PLANNING COMMISSION AGENDA  
October 13, 2016 7:00 PM  
NEWBERG PUBLIC SAFETY BUILDING  
401 EAST THIRD STREET

1. **Columbia Estates Subdivision:** Consider a subdivision tentative plan to divide a 3.06 acre site into 24 lots for single-family detached homes. The site is in the R-2 zone (medium density residential).  
APPLICANT: Del Boca Vista, LLC  
LOCATION: North of Columbia Dr., south of Lynn Dr. TAX LOTS: 3218AB-1700, -1701, -1702  
FILE NO.: SUB2-16-002 ORDER: 2016-24  
CRITERIA: Newberg Development Code Sections: 15.235.060(A)

### PLANNING COMMISSION STAFF REPORT

#### Subdivision Tentative Plan application

# Exhibit C: Tentative Plan

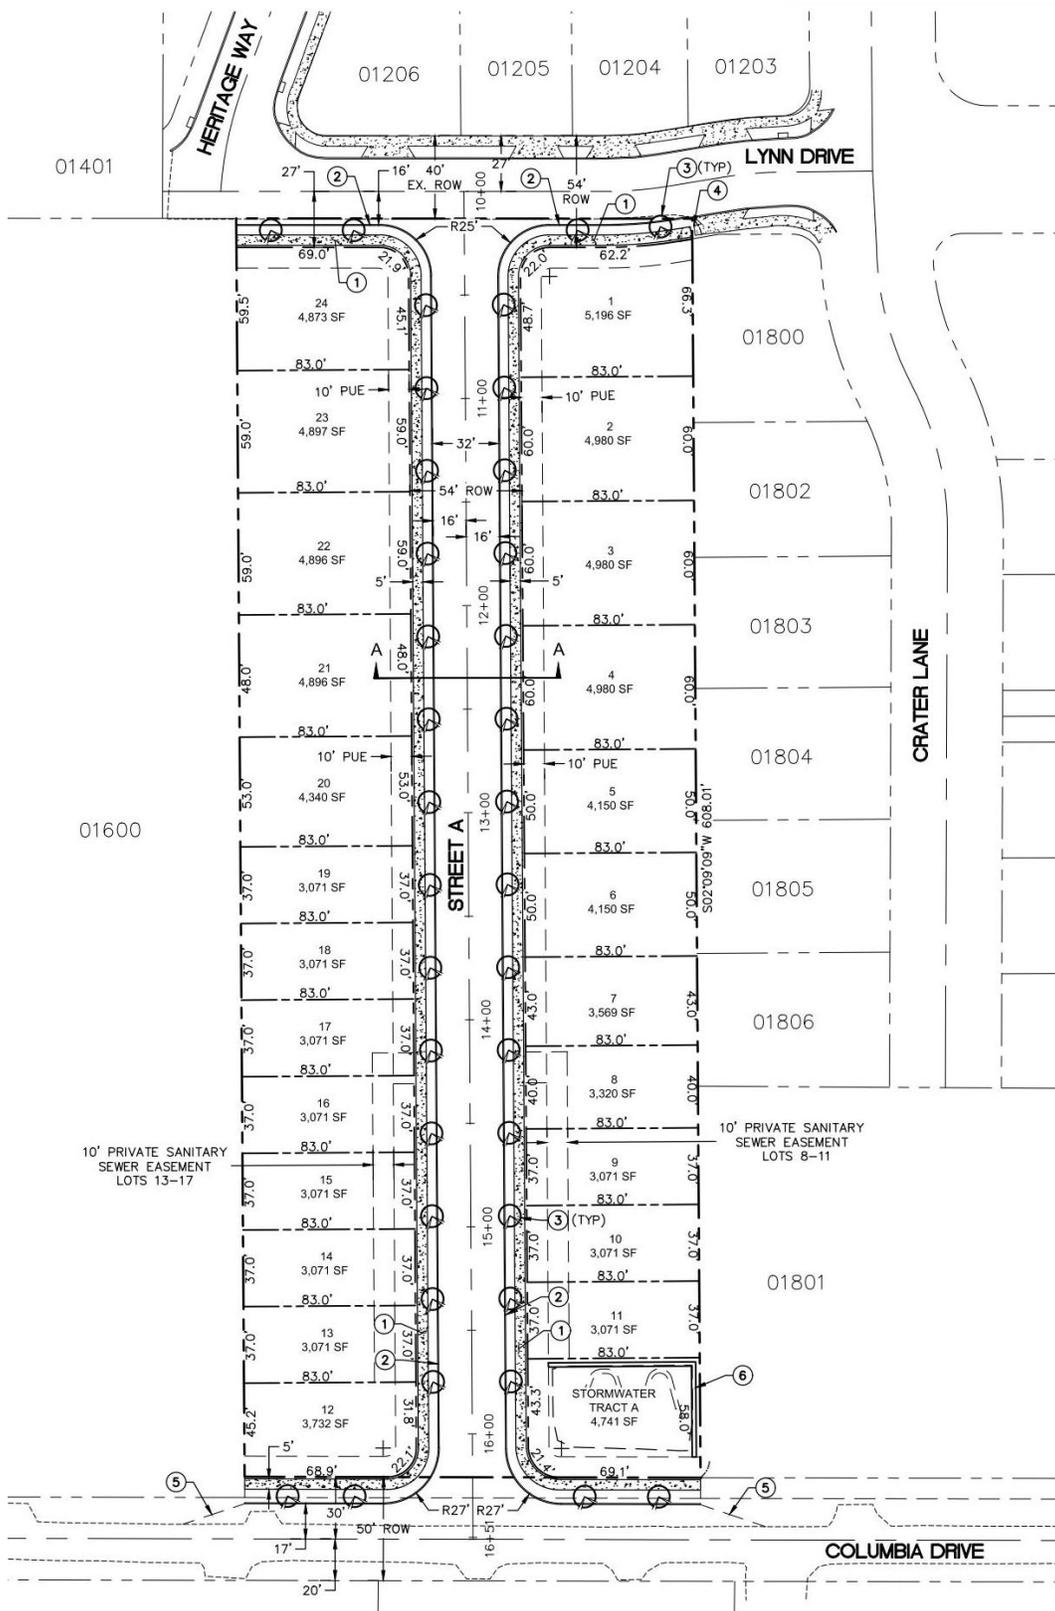
- 6. Stormwater system design:** The applicant will need to submit a revised grading plan showing how the drainage from the slopes along the rear property lines of the new lots will be addressed and/or a lesser amount of fill on the proposed lots.

8. **Phasing:** The proposal is to construct the subdivision in two phases. The first phase will include the northern half of the project. The applicant will need to submit a revised phasing plan including the storm drainage line and the stormwater facility in Phase 1. Additionally in order to meet the fire code, the applicant will need to construct a temporary hammerhead style fire department turnaround south of lots 5 and 20. The plat will need to grant an easement over the hammerhead for fire purposes.

The submitted plans show the water line stopping short of Columbia Drive which would require a future extension of the line to cut the pavement in Street A which does not meet PWDCS 3.2.3.I. The plans submitted for construction shall show the public water line extended into Columbia Drive.

The submitted plans do not indicate the cover over the water line pipe or separation between the water and wastewater lines as required by PWDCS 3.2.3.V. The plans submitted for construction shall show a minimum 36" of cover over the waterline and 18" of vertical separation between the water and wastewater lines. This is not possible with the submitted proposed design of the wastewater line.
